Interactive comment on "Accurate stream extraction from large, radar-based elevation models" *by* M. Metz et al.

Reply to comment n.1

Fig. 1.

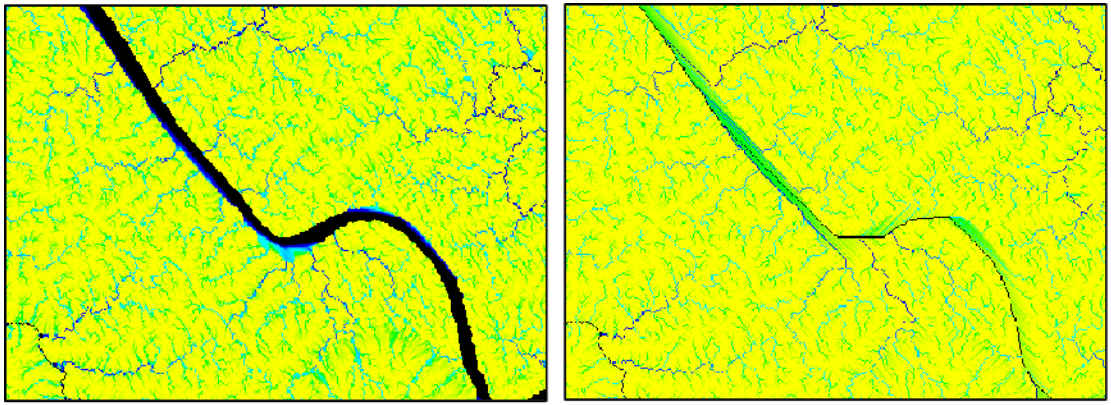
MFD for channel cells, we observed more realistic results using MFD instead of some SFD method for channel cells where the channel is several cells wide (see Figure 1 of this comment)
